Engineering Referral Response

Application Number:	DA2023/0152
Proposed Development:	Construction of a dwelling house on Lot 2
Date:	31/05/2023
To:	Grace Facer
Land to be developed (Address):	Lot C DP 367229 , 6 Orchard Street WARRIEWOOD NSW 2102

~~Basement and Ground Floor Drainage Layout Plan
Drawing No. G22065-SW-100~~

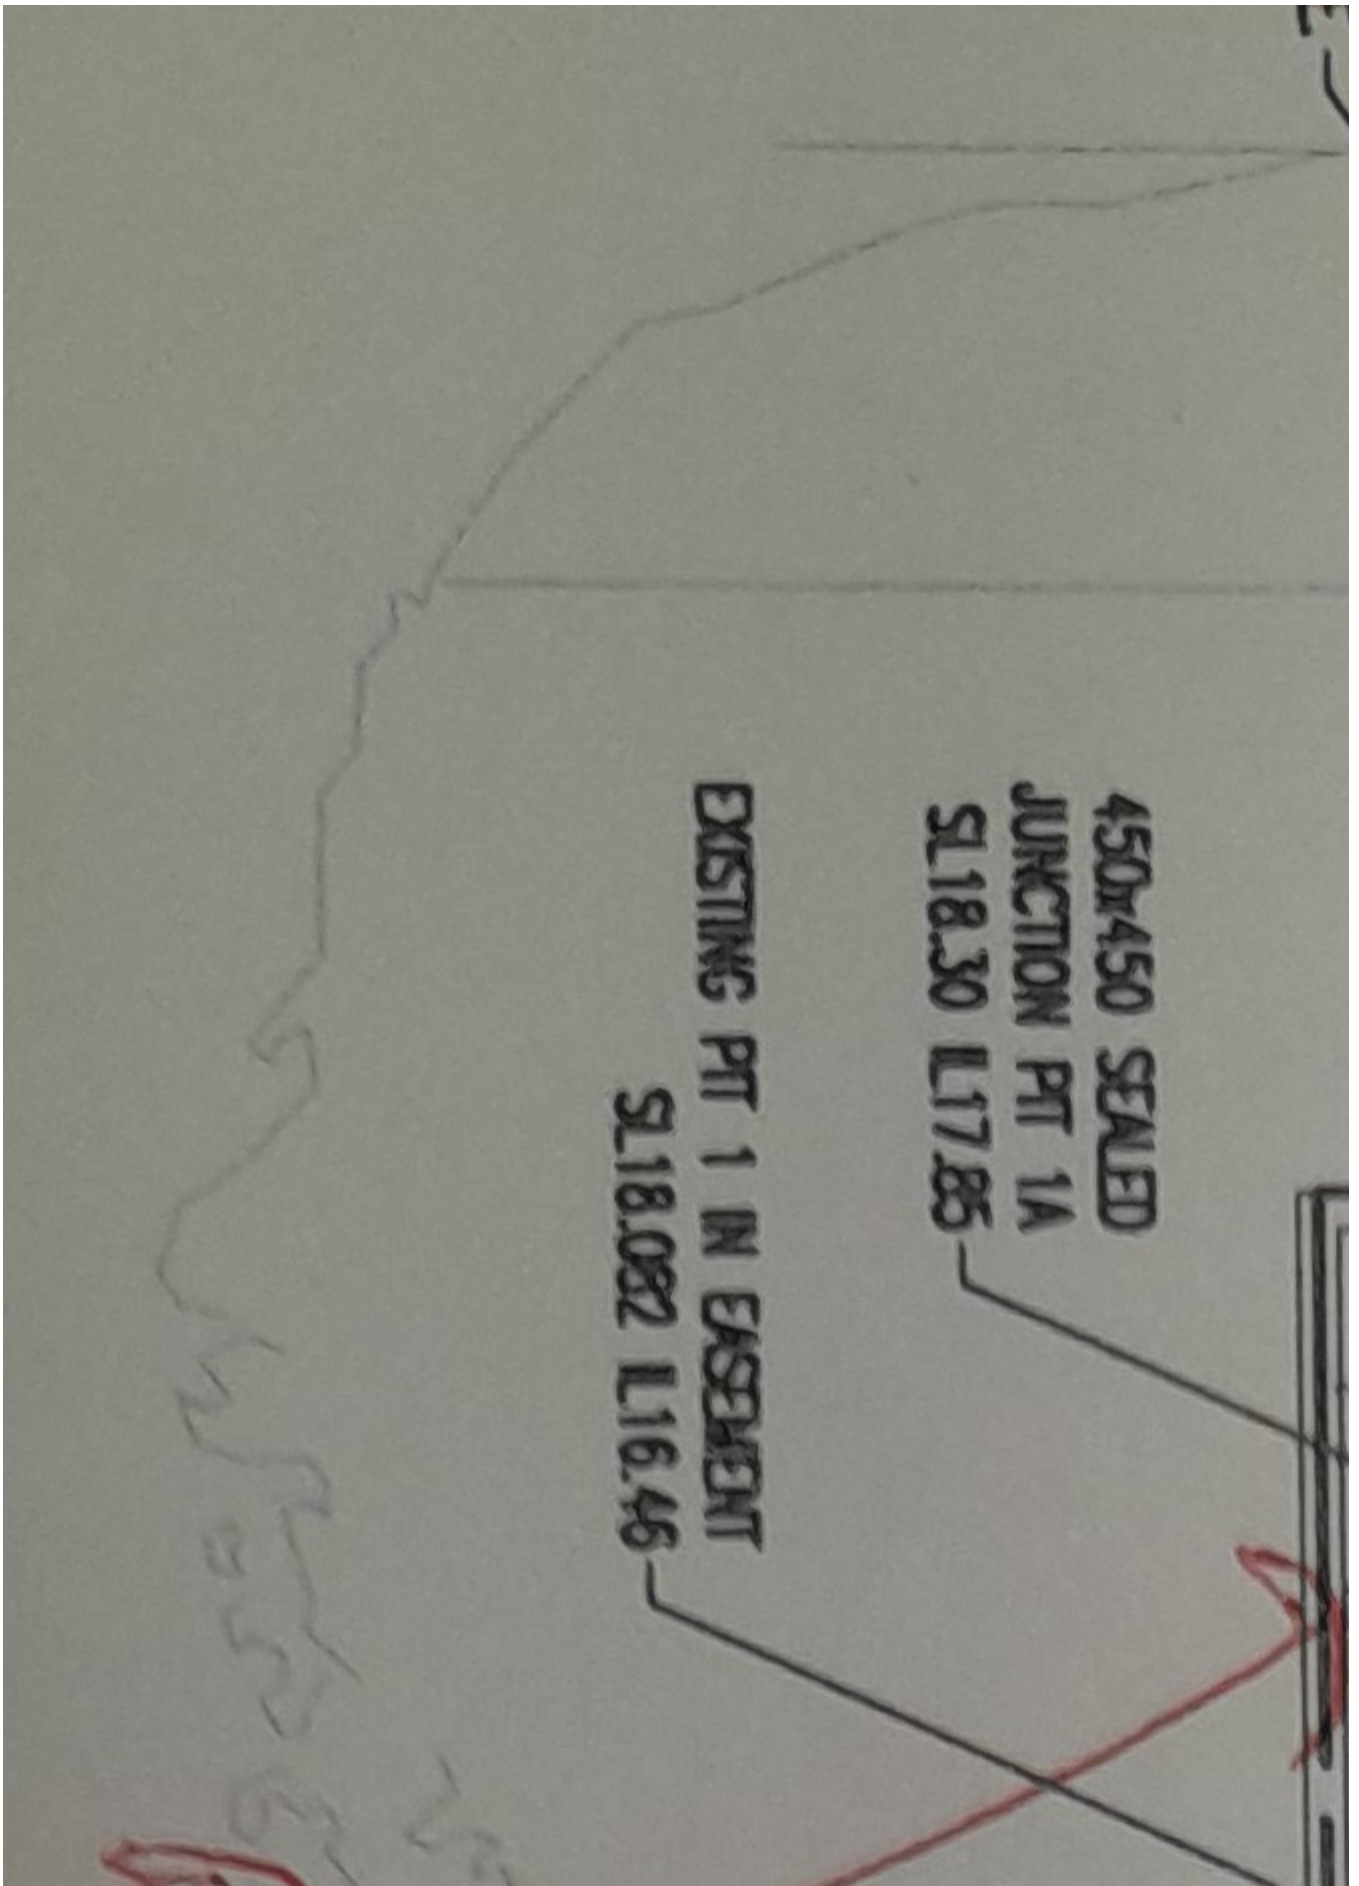
Please provide amendments as per attached sketch.

Show a minimum of 1 metre distance between edge of existing easement pit and proposed pit.

The proposal is therefore unsupported.
